#### NOTICE OF VIOLATION

On May 15, 2024, Energy Safety conducted an inspection of PacifiCorp's WMP initiatives in the vicinity of the city of Weed, California. The inspection report is enclosed herewith. Energy Safety found the following violation:

## **INSPECTION REPORT**

Electrical Corporation:	PacifiCorp (PC)				
Report Number:	PC_CAC12_20240515_0905				
Inspector:	CAC12				
WMP Year Inspected:	2023				
Quarterly Data Report (QDR) Referenced:	Quarter 4 (Q4)				
Inspection Selection:	Energy Safety viewed the contents of the Q4 QDR and performed an analysis that resulted in the selection of				
	the WMP initiatives and locations referenced in this report.				
Relevant WMP Initiative:	Covered Conductor Installation (2023 WMP initiative number 8.1.2.1)				
Date of inspection:	May 15, 2024				
City and/or County of Inspection:	Weed, Siskiyou County				
Inspection Purpose:	Assess the accuracy of PacifiCorp's QDR data, completeness of its work, compliance with WMP requirements,				
	and compliance with its protocols.

Item7IA1Img1: View of one line of covered conductor where two were reported.

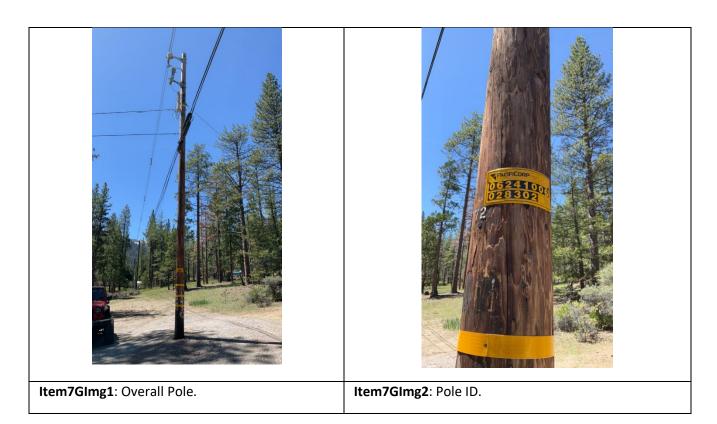
Violation 1. Energy Safety observed that in implementing 2023 WMP initiative 8.1.2.1 - Line Rebuild program - Covered conductor installation, PC failed to report accurate installation data on pole ID 06241006.0028302 at coordinates 41.4284104694565, -122.500040636671 by reporting two lines of Covered Conductor Installation where only one line was installed. Energy Safety considers this data accuracy violation to be in the Minor risk category.

On pole ID 06241006.0028302 at 3935 Stewart Springs Rd, Weed, CA, 96094, 41.4284104694565, -122.500040636671, the inspector observed a single line of Covered Conductor Installation where PC reported two lines. The inspector's observation is documented in Violation 1 photographs, which are attachments to this report. Photo numbers Item7IA1Img1, and Item7IA1Img2 depict only one completed line of covered conductor.

- 1. PacifiCorp reported two lines of Covered Conductor Installation on the subject pole.
- 2. Only one line of covered conductor was installed at this location.
- 3. Energy Safety considers inaccurate data submission to be a violation of the Data Guidelines.
